## Cork County Council

**RE: Part 8 Planning Report for a Maintenance Compound and Park at Kilcoolishal, Glanmire/ Little Island, Co. Cork**

Fig 4. Site Layout Plan

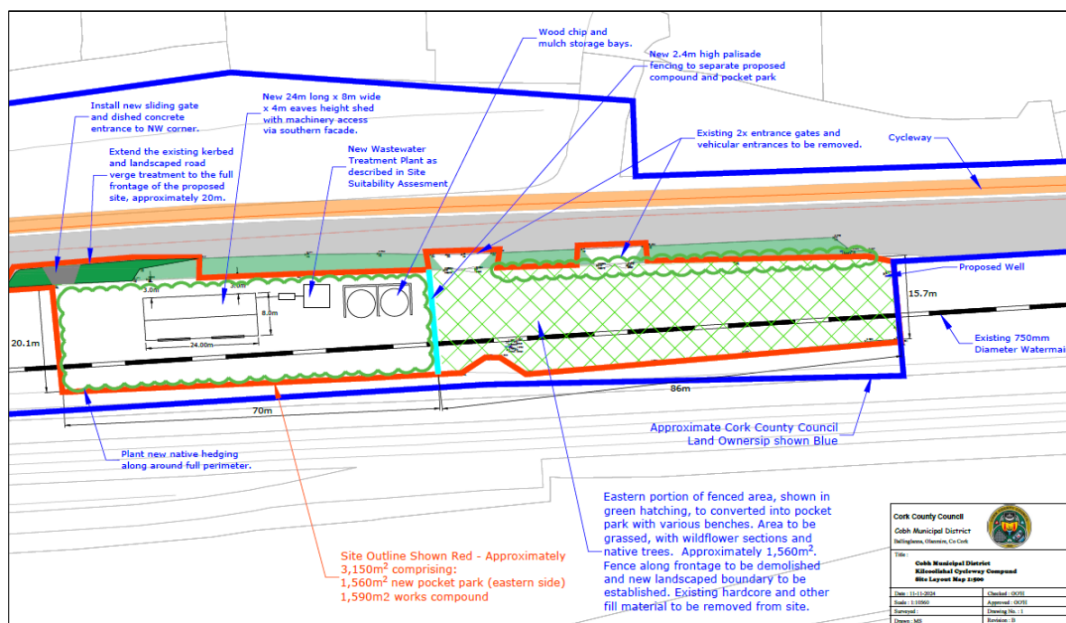
However, detailed design drawings is incomplete, such as internal floor plans, contiguous elevations of proposed structures, boundary fencing and screen planting, detailed site layout plan of compound and park, distinguishing hard and soft landscaping, vehicle parking areas, vehicle entrance detail, planting plans, park seating and furniture. The full suite of statutory drawings should be completed, prior to advertising the scheme, publishing notice.

Fig 5. Site Drainage/ Topography

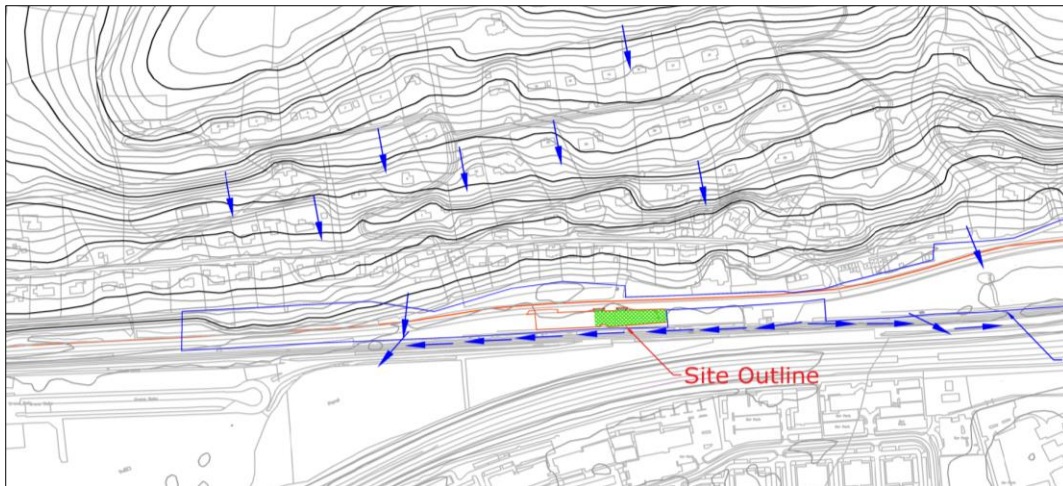
The drainage ditch which runs to the south of the site outfalls c.1.4km to the east into the Great Island Channel Special Area of Conservation (Site code: 1058) and 1.7km to the west into the River Lee and Cork Harbour Special Protection Area (Site Code: 4030). The nearest watercourse comprises of the Tibbstown Stream located c. 240m to the east of the site and discharges into the transitional waterbody of Lough Mahon. According to EPA mapping for the area the ecological status of the Tibbstown is Good and risk status is under 'Review' while the Lough Mahon transitional waterbody was classed as 'Good' and its risk is also under 'Review' under the 2016 – 2021 cycle of the Water Framework Directive. Surface waters and wastewater from the site during construction will be directed to the proposed on-site wastewater treatment system.

It is essential that the wastewater treatment facility is a suitable level above ground (or a sealed unit) to protect against inundation due to failure of the flapped outfalls on the nearby drain. Due to the risk of the L-3004 becoming inaccessible, risks should be limited by warning and preparedness as set out in Section 4.1.2 of this report. There is no risk of pluvial (surface water) or fluvial (river) flood risk identified at the site and the small wastewater treatment facility will handle stormwater drainage on site. The new building would not (materially) increase surface water risk as it will be built on existing ground and is managed by discharging to the existing local stormwater drains. Final design details should be prepared for agreement.

All surface water runoff from hard surfacing areas will also be managed on the site by the on-site Wastewater Treatment Systems. The system must be in full compliance with the guidance and codes of practice as specified in the Cork City Development Plan 2022-2028 SFRA. Final design details should be prepared for agreement.

Fig 7. Flood Zone 'A' Layers: CDP & National Coastal Flood Hazard Maps

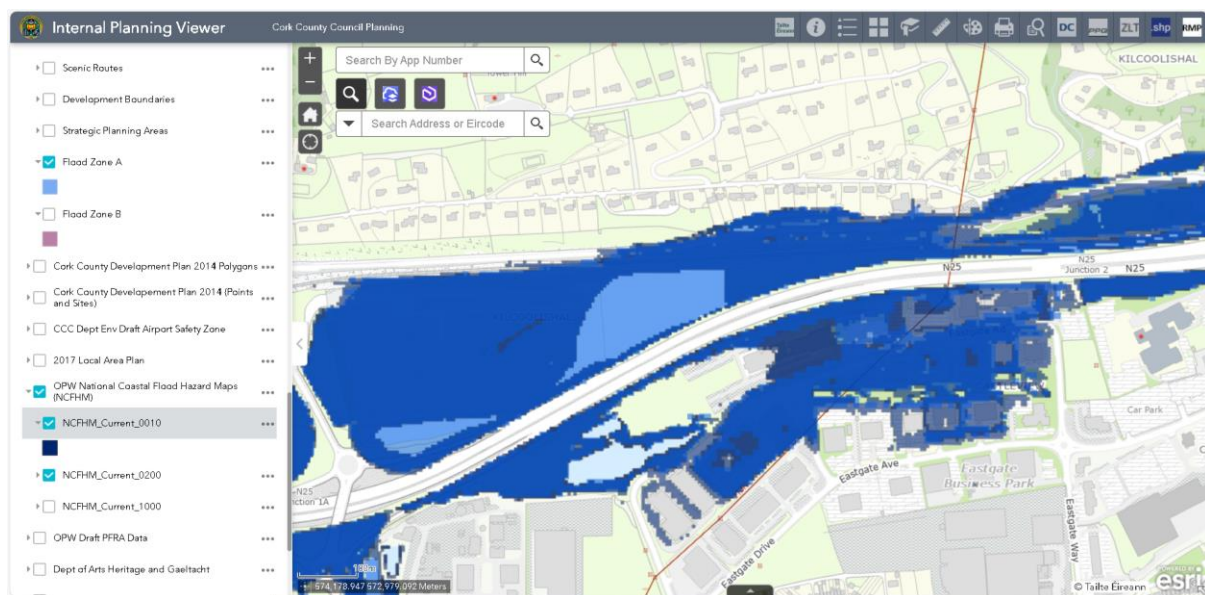
The site lies within Flood Zone A/B, fluvial and in particular tidal flooding. Data is utilised indicating depths of up to 1.5metres. The ground levels at the site range from 1.46mOD at the southwest of the site to 3mOD at the northwest of the site. There is a drain on southern boundary indicated to be 2.0metres below site ground levels.

Flood risk information in the area is provided by the CFRAM (fluvial & coastal), the NCFHM (coastal) studies. According to the datasets the site is located in Flood Zone A & B. There is no flood relief scheme that covers the site. The report describes modelling to be conservative, and suggests that the railway acts as a barrier to tidal floodwaters, (without verifiable evidence). The Dunkettle Interchange Upgrade model of water levels and risks is not available at this time. In short, reliable information is not available at this time.

The report states that it is not feasible to raise FFLs of the compound to the standard of 500mm freeboard above the 0.5% coastal plus climate change event. Note. It would be contrary to best practice to raise lands within flood zone as it may result in adverse impacts on adjoining lands.

Therefore, the report proposes that risks be managed through Resilience Measures, Flood Emergency Response Plan and appropriate SWM measures.

Flood resilient construction should be implemented, which could be achieved by using wall and floor materials that can be cleaned and dried relatively easily, provided that the substrate materials are also resilient. Electronics, appliances and water sensitive fittings should be kept as high as practicable above FFLs. It would be advisable to keep these fittings at least 2m above finished floor levels to account for extreme water depths in the unlikely event that the flapped outfalls to the drain fail and allow the drain to overtop and let tidal waters on to the site. Any fuel/oil or hazardous material storage should also be kept at or above this level. Non return valves on the surface water/foul system may also be appropriate. It is essential that the wastewater treatment facility is a suitable level above ground (or is in a sealed unit) to protect against inundation due to failure of the flapped outfalls on the nearby drain. This may present some significant design challenges and/or require pumping. Any WC facility within the building would need to have a non-return valve fitted. Detailed design measures should be completed.

Flood Emergency Response Plan including contingency measures such as the timely evacuation of the site prior to the onset of flooding. The plan should be prepared for agreement.
